UNITED STATES PATENT AND TRADEMARK OFFICE

10/550,635

Office Action Summary	Application No. 10/550,635	Applicant(s) BARRENBURG ET AL.	
	Examiner ALYSON M. MERLINO	Art Unit 3673

DETAILED ACTION

FIG.8

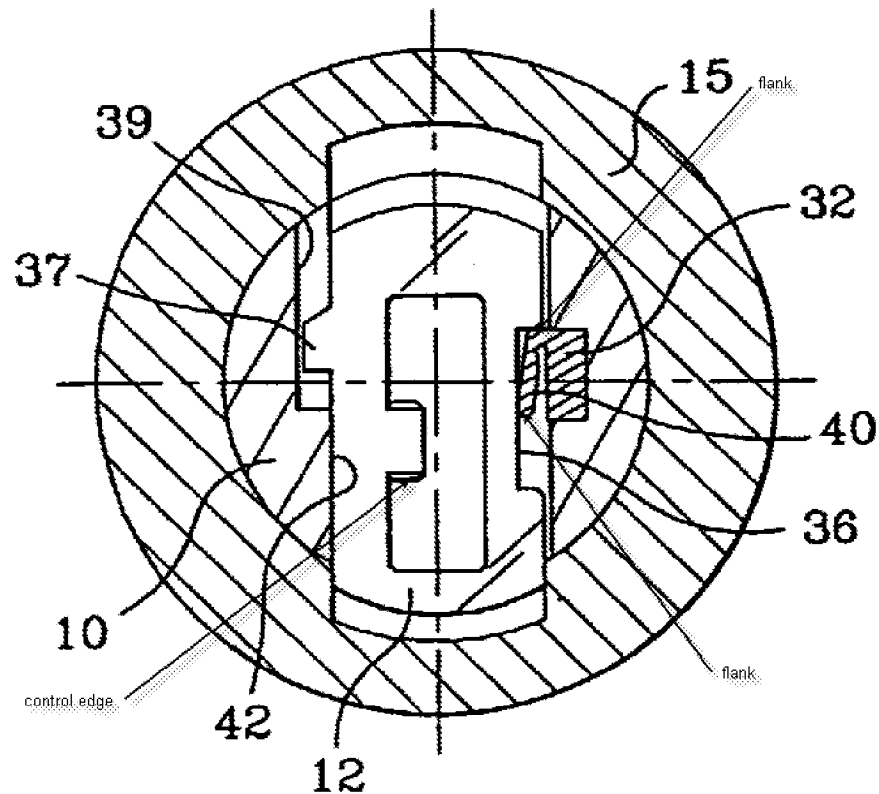
9. **In regards to claims 1-4**, Demouy discloses a lock cylinder (Figure 8) including a cylinder housing 15 and a cylinder core 10 rotatably supported in the housing (Figure 8), and a key 18 with a defined longitudinal profile being assigned to the core (Figure 9). Demouy further discloses a group of diametric shafts 14 arranged in a row in the axial direction of the cylinder core (Figure 1), which hold plate-shaped tumblers 12 that include longitudinal edges that are free to slide longitudinally along guide surfaces 42 (apparent from Figures 8 and 9) of the shafts. Demouy discloses that each tumbler has a control edge (see figure below) in correspondence with the longitudinal key (Figure 9), and each control edge being located at a defined height (apparent from profile of key, Figure 1). Demouy further discloses a radial opening 33 in the cylinder core for

insertion of an insert 32, with an outer end (end near indicator of reference characters 32, Figure 8) of the insert never projects beyond an external contour of the cylinder core after insertion of the insert in the opening with the insert being fixed in position (apparent from Figures 8 and 9) in the opening, whereas an inner end (end opposite the outer end, closest to tumbler 12, Figure 8) always engages in a cutout 36 in the facing edge of the longitudinal plate edge of each of the tumblers (Figures 1, 7, and 8) during operation of the lock cylinder (apparent from Figure 9). Demouy also discloses that each of the tumblers are secured in the cylinder core (apparent from Figure 1), and that the insert consists of a non-displaceably positioned comb-shaped body (apparent from Figures 3 and 8) with teeth 40 extending from the comb-shaped body, with the tumblers arranged in a common plane with the teeth (cross-sectional plane shown in Figure 8), with the teeth having inner ends that include a profile with at least one pair of oppositely-facing flanks (see figure below). Demouy discloses that the cutouts in the tumblers have at least one pair of opposing flanks 38 (Figure 7), and the flank pairs and the opposing flank pairs are arranged so that the control edges of at least two tumblers are at the same height (apparent from Figure 1). Demouy further discloses that in a rest position of each of the tumblers, only one of the flanks of a flank pair of the at least one pair of oppositely-facing flanks rests against one of the opposing flanks of the at least one pair of opposing flanks (apparent from Figure 8) and in an actuated position the other flank of the flank pair meets the other opposing flank (apparent that maximum displacement of tumbler 12 upward would have the bottom flank meet the other opposing flank, Figure 9). Demouy fails to disclose that the tumblers are spring-loaded,

13. **In regards to claim 9**, Demouy discloses that the maximum point of the tooth profile (near upper flank, see figure above) is positioned in the cylinder core so that it “essentially” lies on a traverse plane (plane extending from side of core with insert towards side with reference character 37, Figure 8) of the cylinder core.
